**AGENDA
CITY OF CEDAR FALLS, IOWA
PLANNING AND ZONING COMMISSION MEETING
WEDNESDAY, AUGUST 14, 2024
5:30 PM AT CITY HALL, 220 CLAY STREET**

2. **HWY-1 District Site Plan for Golden China restaurant at 1150 Brandilynn Blvd. (Case #SP24-004)**
Petitioners: Darren Fang, LLC, owner; Dan Levi, Levi Architecture; Monica Smith, Robinson Engineering
Previous discussion: none
Recommendation: *Denial*
P&Z Action: *Discuss and make a recommendation to approve, deny, or continue the discussion to a future meeting to give time for the applicant to make modifications.*

TO: Planning and Zoning Commission
FROM: Thom Weintraut, AICP, Planner III
Ben Claypool, Civil Engineer II, PhD., PE.
DATE: August 14, 2024
SUBJECT: HWY-1 District Site Plan for Golden China

REQUEST: HWY-1 District Site plan approval for construction of a new restaurant, Golden China, on Lot 4 of Pinnacle Prairie Commercial South, Phase V (Case # SP24-004)

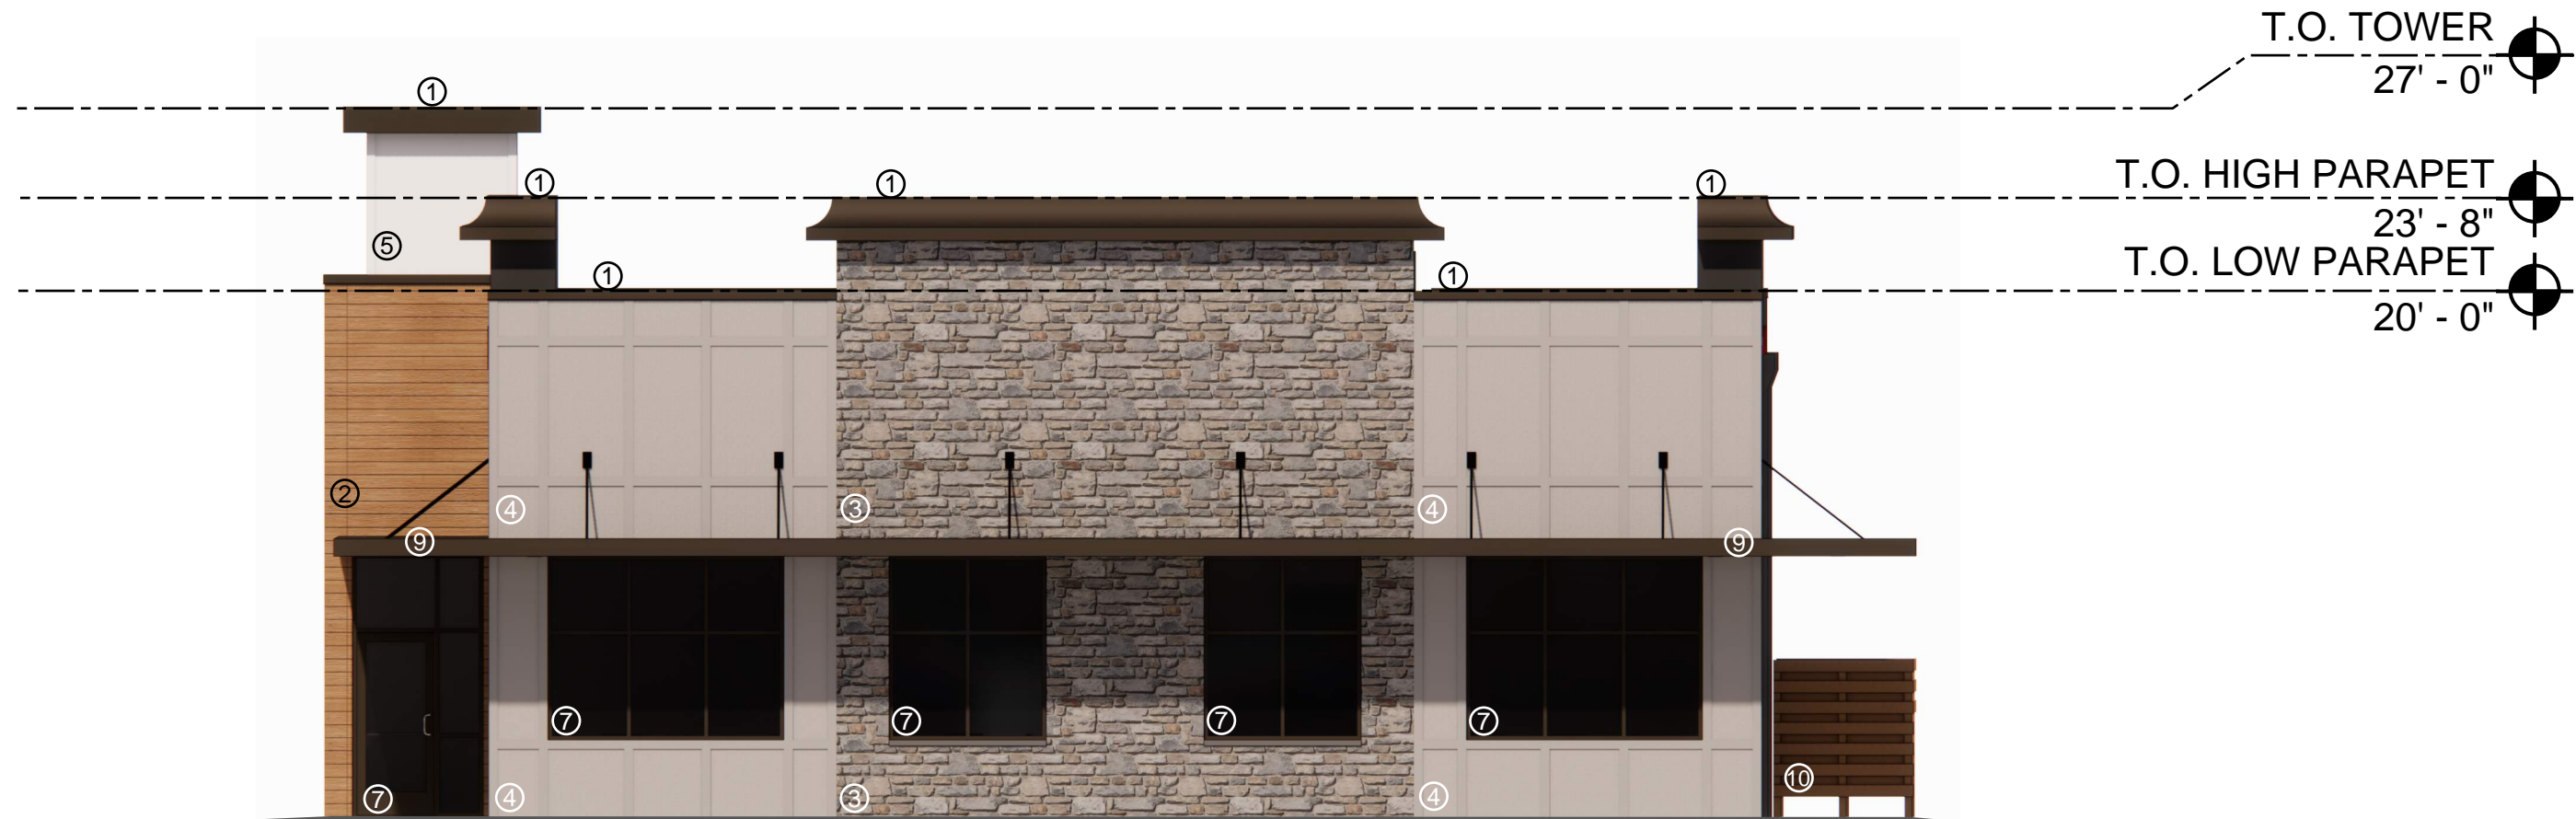
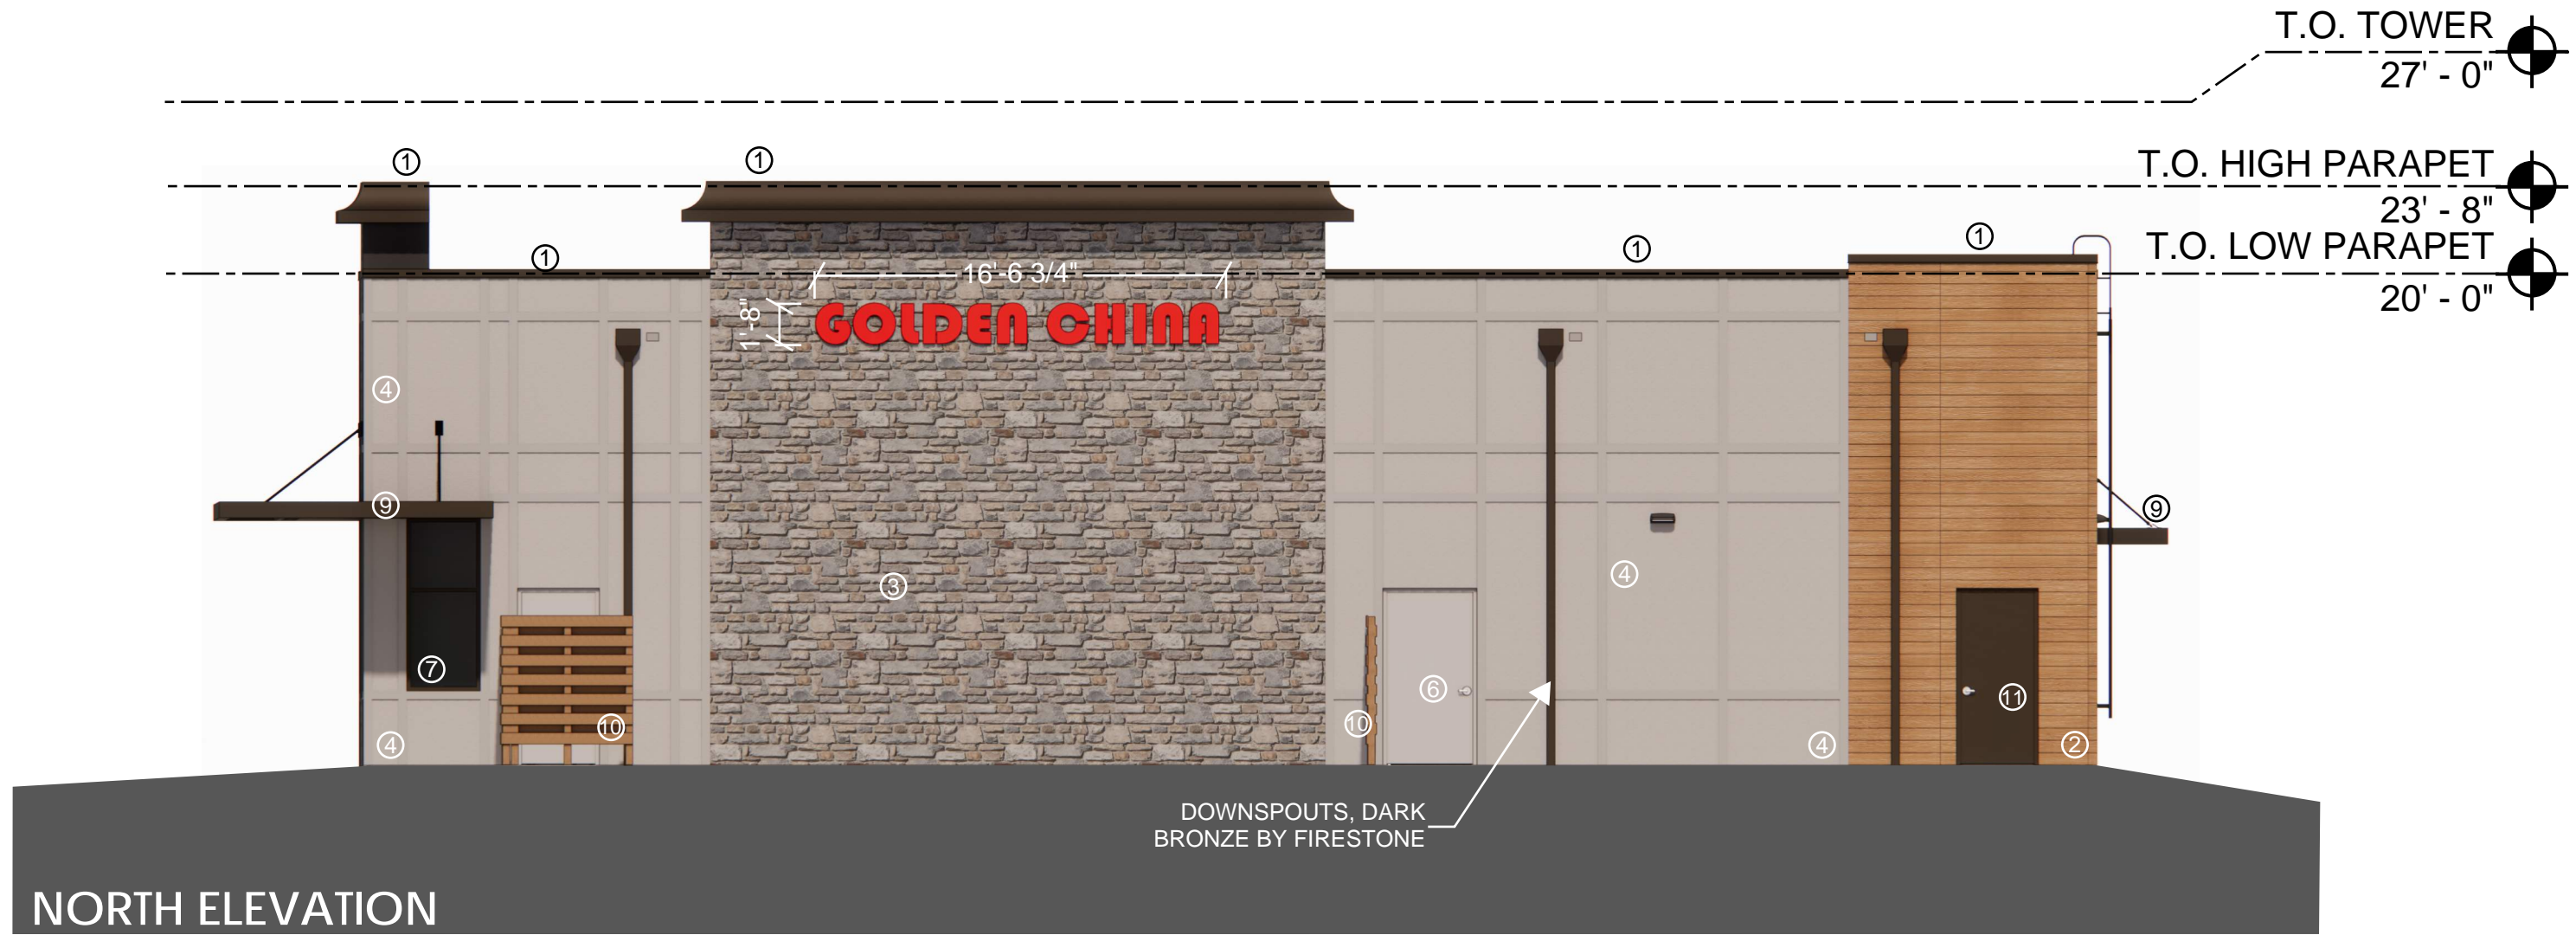
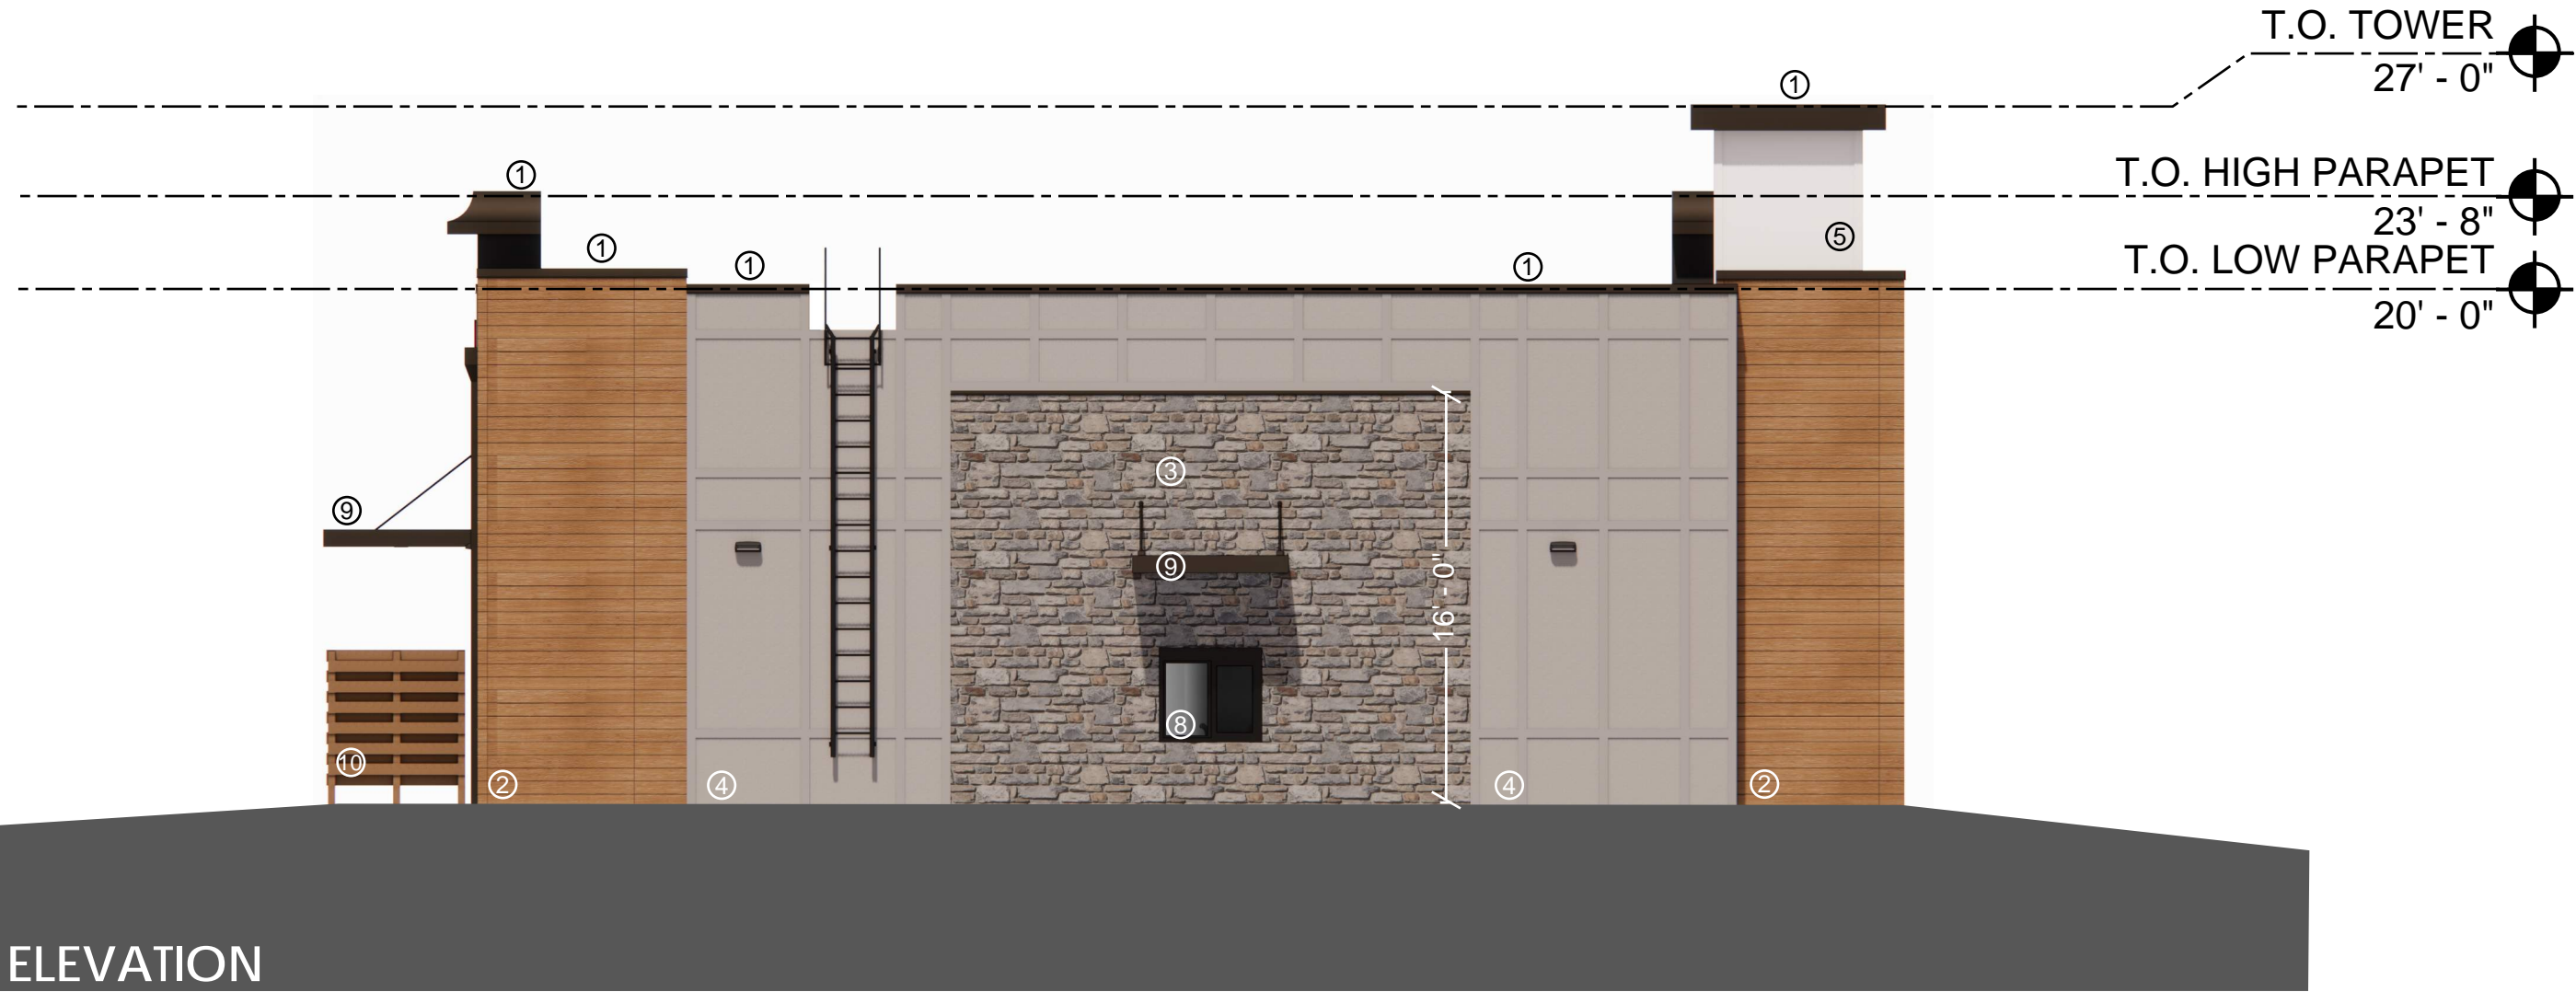
As shown above the street-facing façade has few windows and doors, so does not have a pattern discernible to viewers and is not consistent with other buildings in the area. On the south, west, and east-facing elevations, the placement of windows and board and batten siding create a strong vertical rhythm, while the use of the canopy on these two façades provides horizontal relief. The brackets for the awning introduce an additional rhythm to these elevations. The windows are well-distributed across the three facades that do not front of Brandilynn Boulevard. The Brandilynn Boulevard side of the building, because it is the service entrance, does not provide strong horizontal or vertical rhythm that come with the use of windows and doors with lights.

In summary, the proposed restaurant has a high quality of design and materials; however, because of the building's orientation with the "rear" facing the street, the street façade is not compatible with the other three buildings. Staff finds the architectural standards of the HWY-1 Zone are not met.

ENCLOSURE SIDE ELEVATION

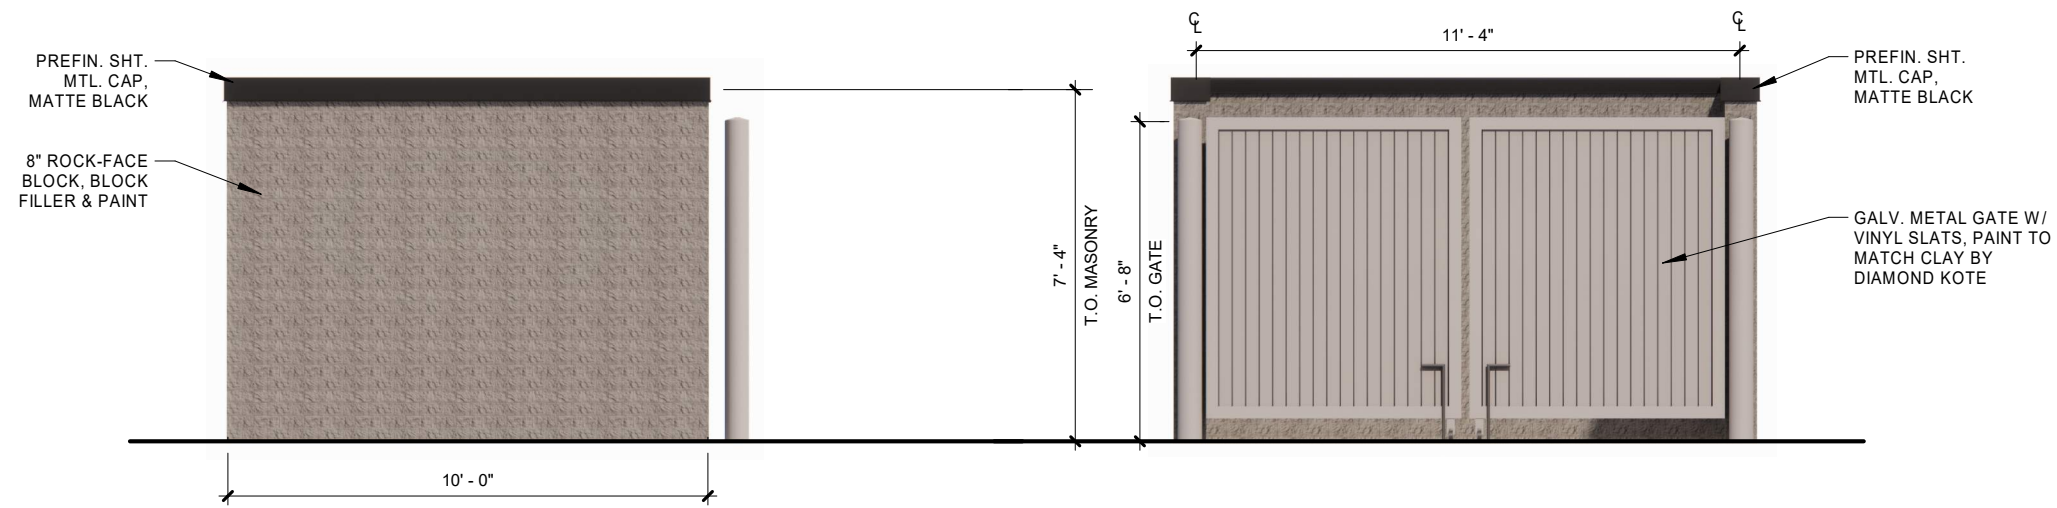
- 8) Trash Dumpster Site: The dumpster enclosure is located at the northwest corner of the building. This location is in a highly visible from Brandilynn Boulevard. Trash enclosure is over seven feet in height and will be constructed using a rock-face block painted to match the gray board and batten siding. The gate is metal and over six feet high and will be clad with vinyl slats resembling vertical boards.

The dumpster enclosure meets City standards; however, the placement should be in a less visible location and not in the front yard and visible from Brandilynn Boulevard.
